**ADDENDUM NO. 2**

**2022C Houston Clinton Drive – RFP 2024-008**  
**PID: CIPTR-2022C**

SIDEWALK DRAINAGE CROSSING DETAILS  
N.T.S.

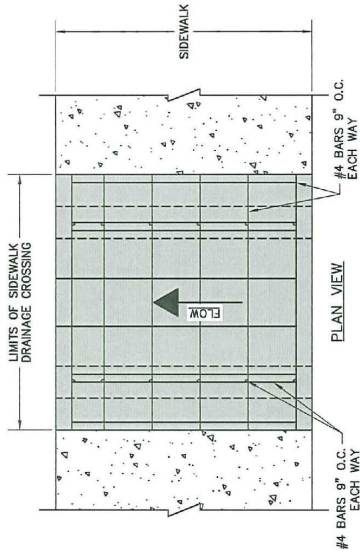
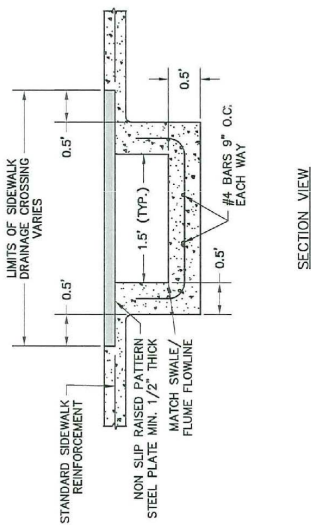
- a) This addendum clarifies a question brought up during the pre-bid meeting regarding the sidewalk and drainage swale crossing detail. Item 26 of the bid tab calls for a special curb sidewalk inlet as identified on the sheet 14 of the civil drawings. However item 27 calls for sidewalk steel plate.

- Per this addendum, item 26, and detail on sheet 14 are hereby considered the base bid.
    - Item 27 can be installed in lieu of item 14 per the detail below.

- The bidder shall one of the items, and only install one.
  - b) See below the alternative detail for steel plate. Contractor shall install adequate number of these to make up for the required 8' inlet opening.
